## UNITED STATES PATENT AND TRADEMARK OFFICE

APPLICATION NO.	FILING DATE	FIRST NAMED INVENTOR	ATTORNEY DOCKET NO.	CONFIRMATION NO.
10/635,919	08/06/2003	Claudius Zeiler	5858-00800	8849
7590	12/08/2008		EXAMINER	
Conley Rose, P.C. P.O. Box 684908 Austin, TX 78768-4908			SWIGER III, JAMES L.	
		ART UNIT	PAPER NUMBER	
		3775		
		MAIL DATE	DELIVERY MODE	
		12/08/2008	PAPER

<b>Office Action Summary</b>	<b>Application No.</b> 10/635,919	<b>Applicant(s)</b> ZEILER ET AL.
	<b>Examiner</b> JAMES L. SWIGER III	<b>Art Unit</b> 3775

**DETAILED ACTION**

Fig.17

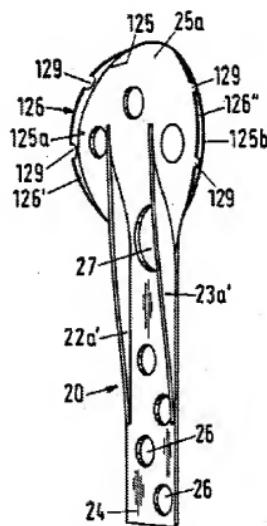
Herzberg discloses an implant plate (Fig. 17, 20) for stabilizing a fracture having a plate member (20) with holes (26) for bone screws (see Col. 7, lines 25-35) located on both the head and shaft portion, at least one receiving member (129) for receiving flexible cerclage wires (see Col. 9, lines 55-60) and wherein these receiving members face away from bone (as shown in the side profile in Fig. 18) and is considered hook-like and also is substantially circular. The notches allow for passage and tightening of suture material after the plate has been secured. Fig. 17 appears to be a one-piece plate and the plate further has a head end (25a) as well as a shaft end (24) that is narrower than the head end. The head and shaft portions are designed to be placed against the bone and further capable of being placed against upper arm head bone and also proximal upper arm bone. It is noted that Herzberg also mentioned that the implant plate may be made from any of a number of suitable materials. With regards to the one-piece plate being cut or punched from a metallic strip material, this is considered a

Herzberg discloses the claimed invention except for specifically a suitable material that is implant steel or titanium, the plate being bent, or the plate having a uniform thickness that ranges from 0.5mm to 6.5mm or from 0.8-3.5mm. Carter shows a fracture fixation plate that is bent (see 22, and also Col. 2, lines 50-60). Besides having a plate shape based on it's suitability, Carter discloses that this shape modification allows it to better fit the target bone area. Additionally, Carter discloses that a plate may also be between 2-3mm and that the plate may be made of any known biocompatible material such as titanium or stainless steel. It would have been obvious to one having ordinary skill in the art to construct the device of Herzberg having specifically a suitable material that is implant steel or titanium, the plate being bent, or the plate having a uniform thickness that ranges from 0.5mm to 6.5mm or from 0.8-3.5mm in view of Carter so that the plate can have optimum fit in the target area and also have proper biocompatibility.
